# SERVICE AND APPLICATION NOTES

H-12-11

## G43/G51/G61/G71 Cold End Header Box Replacement For 045 and 070 Unit Sizes

FIGURE 1

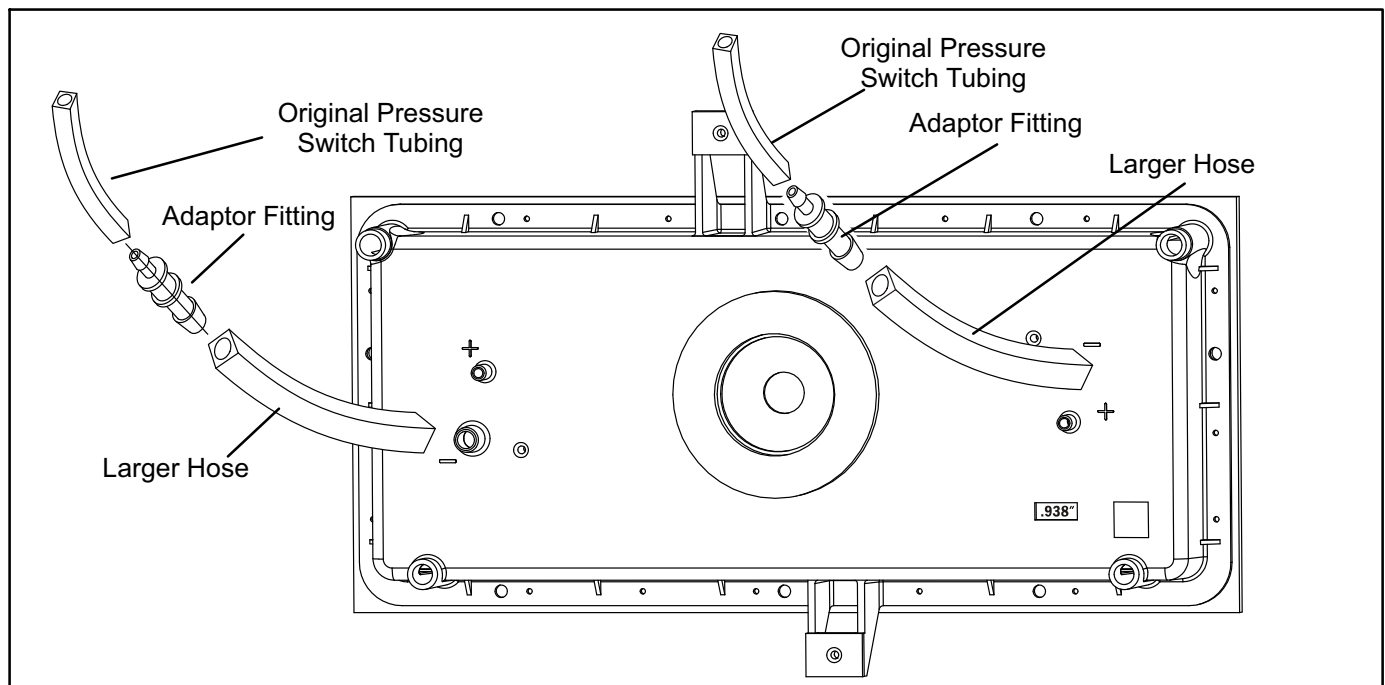
We have increased the size of the negative pressure port on the replacement CEHB for these input furnaces. The new larger port has tested successfully in not plugging during operation. Each new replacement CEHB kit (figure 1) includes a new CEHB with the larger port, a larger pressure switch hose for connecting to the port and an adaptor fitting to transition to the original pressure switch tubing in the furnace. Table 1 shows which kit to order based on model family, unit input and dash number.
